OG-01-047 NRC Project Number 686

Subject: Westinghouse Owners Group
Revised Response to NRC Request for Additional Information on WCAP-15338, "A Review of Cracking Associated with Weld Deposited Cladding in Operating PWR Plants," (MUHP-6110)

NRC Request for Additional Information Regarding the Review of WCAP-15338

WOG Revised Responses to NRC Questions Regarding Vessel Integrity Assessment

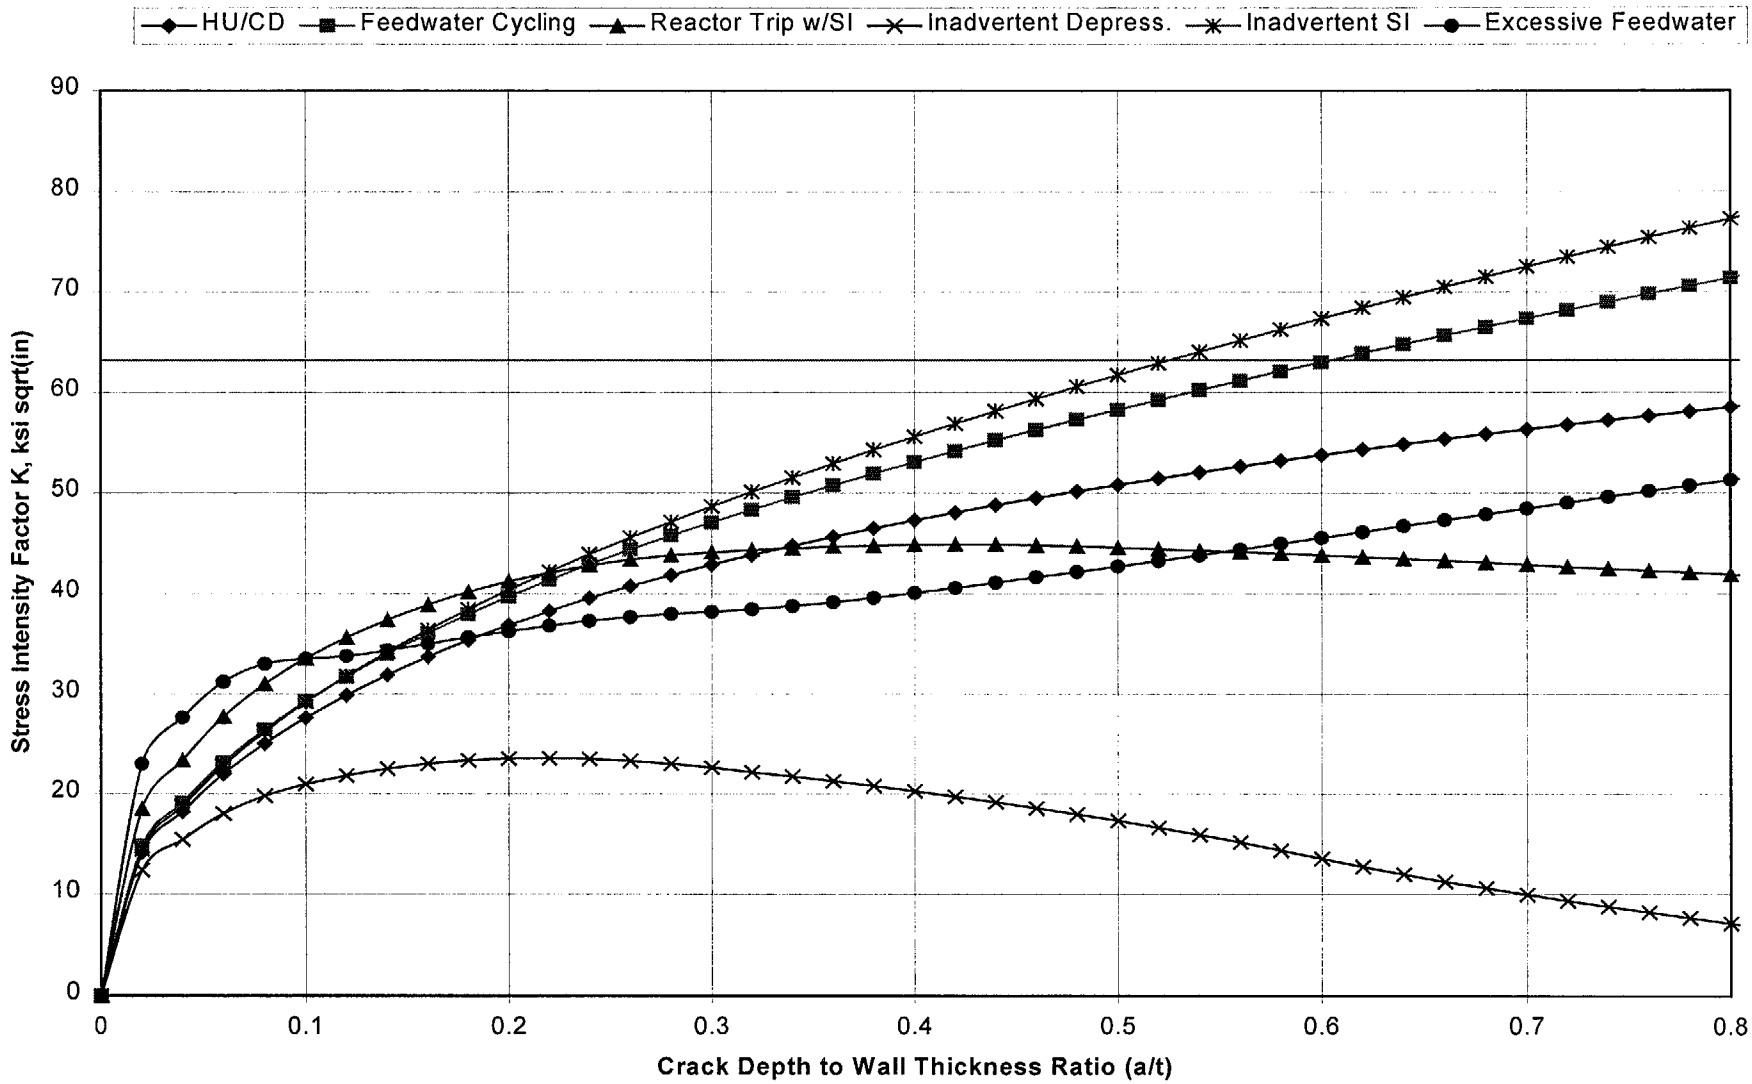
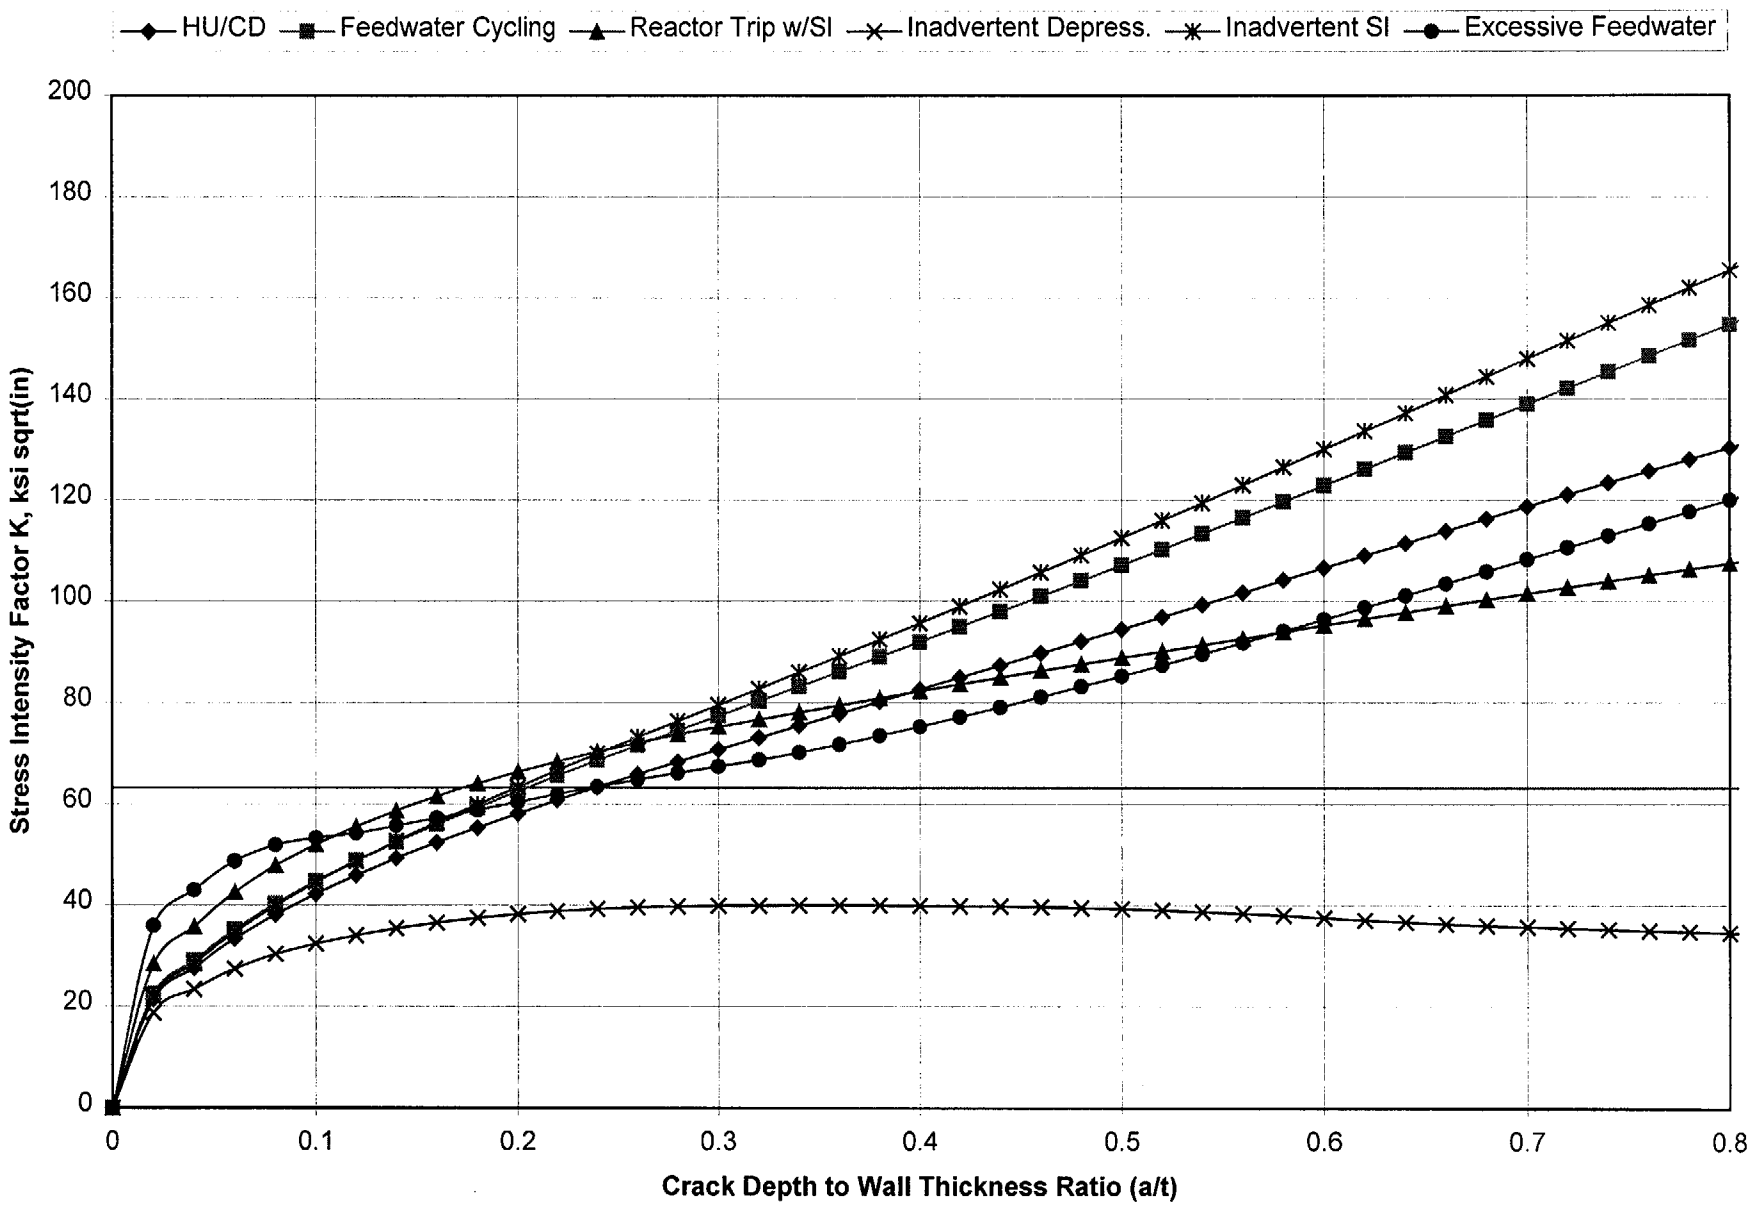
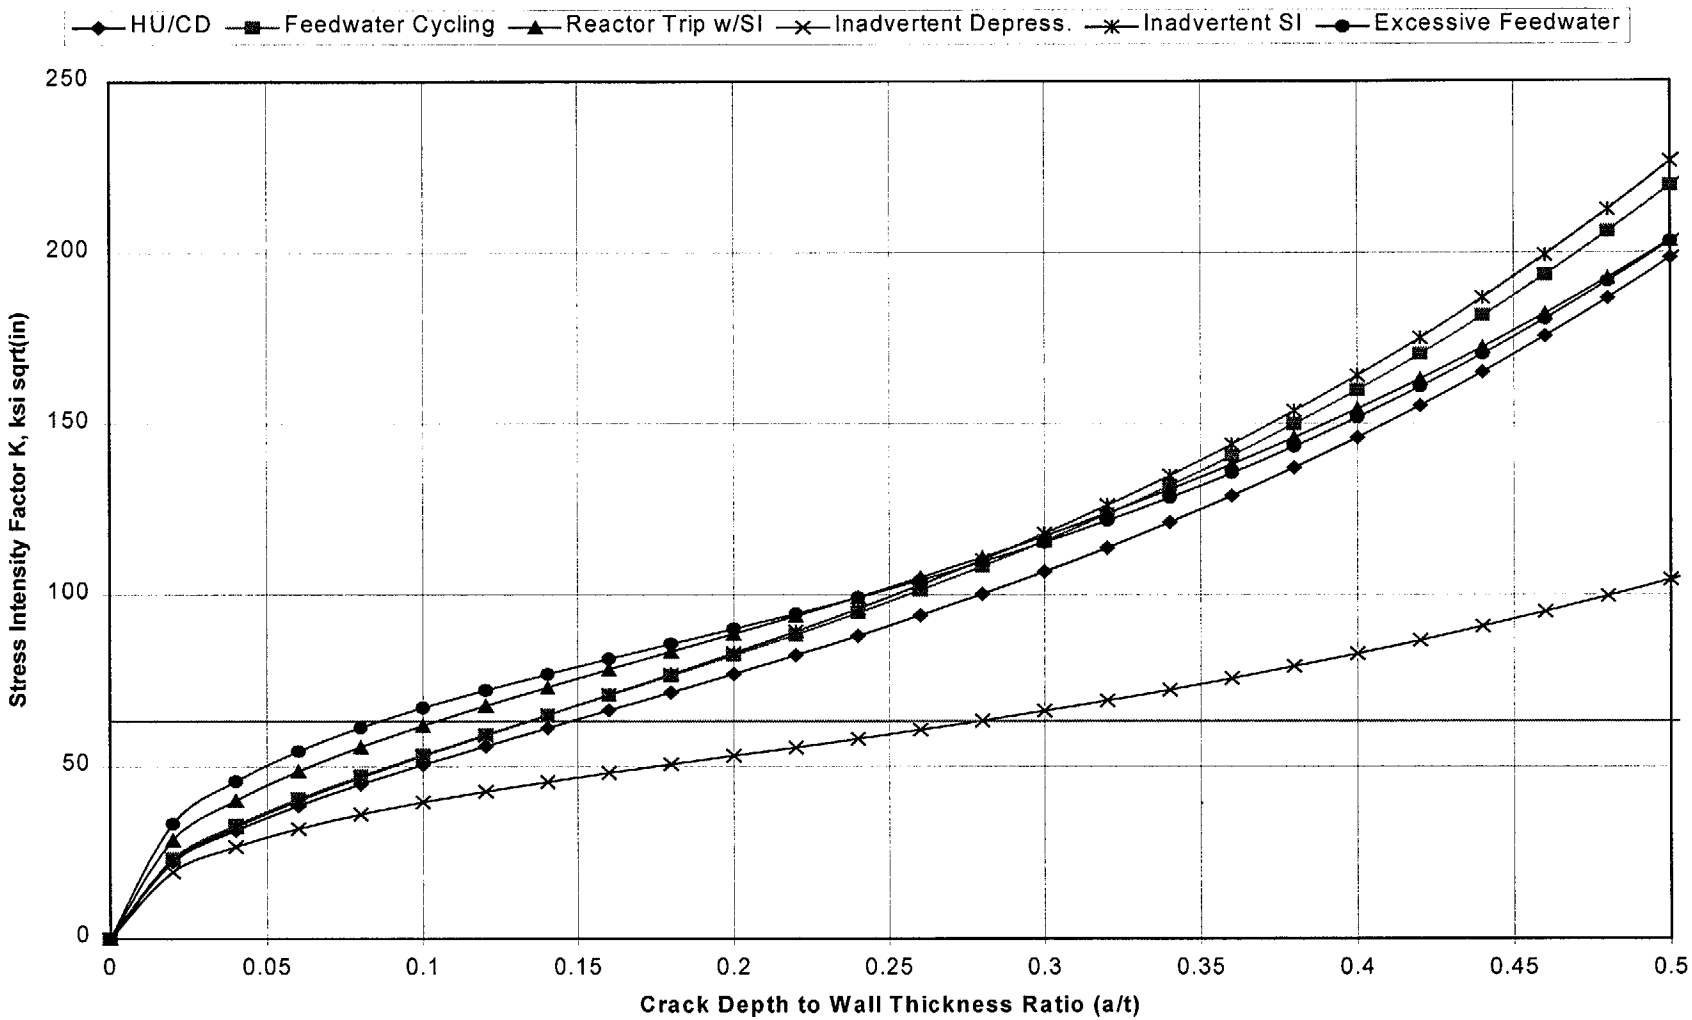
1) Since it can not be ensured that the cracks will not penetrate the clad, the fatigue crack growth evaluation should be performed using the ASME Code Section XI reference crack growth law for water reactor environment. The postulated surface flaw should have an aspect ratio of 6:1 and its depth should include the clad thickness and bound the size of flaws observed during fabrication. Does the 0.295 inch crack depth discussed in the report represent the bounding size of flaw observed during fabrication or does it include the clad thickness?

a) The projected flaw length at the end of the license renewal period should be evaluated to the criteria in ASME Code Section XI, Paragraph IWB-3600. The fracture mechanics evaluation should include: (1) all forging materials that were susceptible to the under clad cracking (i.e. beltline, nozzle belt, vessel flange etc.), (2) embrittlement of beltline forgings at the end of the license renewal term, (3) cladding effects, (4) axial and circumferential flaw configurations, and (5)normal/upset and emergency/faulted conditions.

The minimum allowable flaw size was calculated using the most governing transients under normal operating conditions for the location of interest. To select the most governing transients for the beltline region, the stress intensity factors (K_I) for several normal, upset and test conditions were calculated for axial flaws in the beltline region. The axial flaws were chosen since the hoop stresses are higher than the axial stresses in the beltline region, as can be evident from the crack growth results in Tables A-3.1 and A-3.2. The stress intensity factors are plotted in Figures A-4.1 through A-4.3 for three different flaw shapes. Note that several transients were considered for each flaw shape, to ensure that the most governing transient would be chosen. The allowable flaw depth was chosen as the intersection of the stress intensity factor curve with the allowable fracture toughness, which is $200/\sqrt{10} = 63.2\, ksi\sqrt{in}$. The minimum allowable flaw size results for normal, upset and test conditions are provided below:

Flaw Shape	Governing Transient	Allowable Flaw Size	
		inches	(a/t)
Aspect Ratio 2:1	Inadvertent Safety Injection	4.07	(0.525)
Aspect Ratio 6:1	Reactor Trip with Cooldown and S.I.	1.34	(0.173)
Continuous Flaw	Excessive Feedwater Flow	0.67	(0.086)
